**RE: Duke Energy Carolinas, LLC's and Duke Energy Progress, LLC's
Comments in Support of Inspections for Legacy Solar Generating
Facilities
Docket No. E-100, Sub 101**

2018/2019 Periodic Inspection Pilot Findings

Grid Reconnect Timer

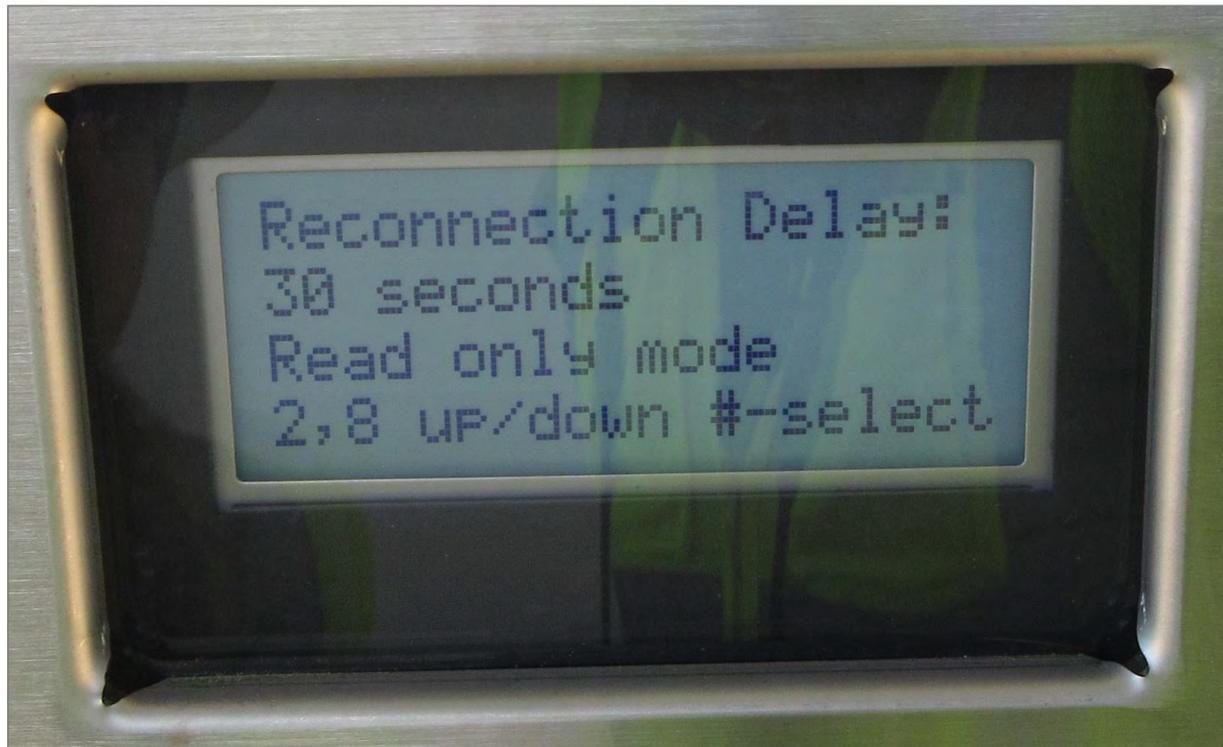
Reconnect timer set to 30 seconds instead of required 300 seconds.

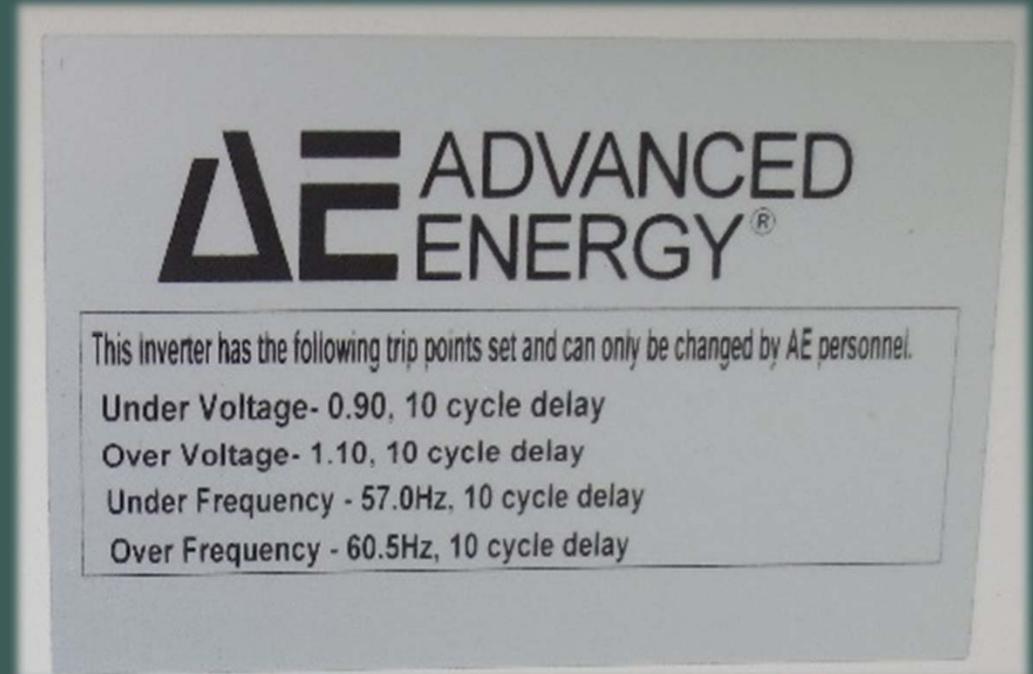
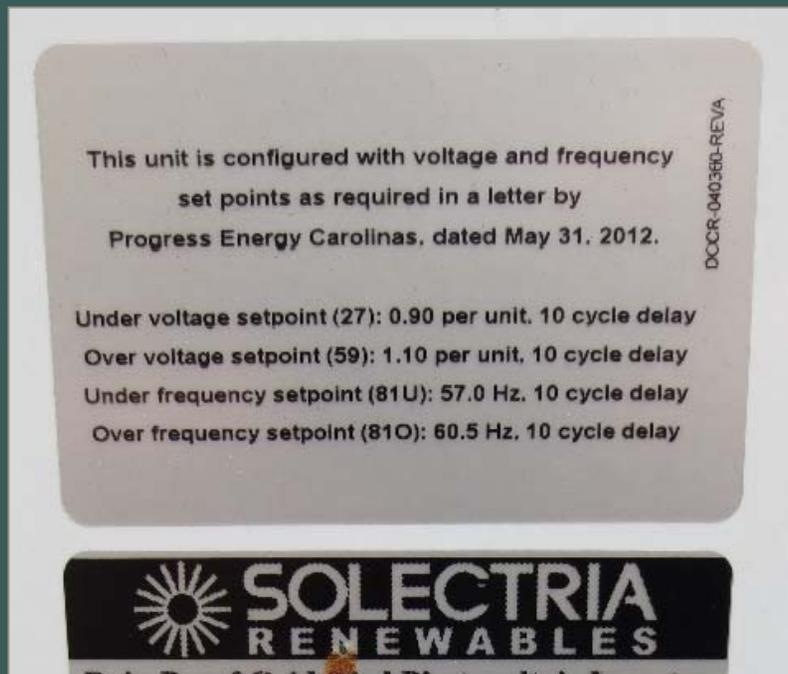
Inverters at 4 sites labels installed on the inverters indicating interconnection protection settings had been adjusted at the factory to utility specified values

However, we found the actual inverter internal settings did not agree with those specified on the labels
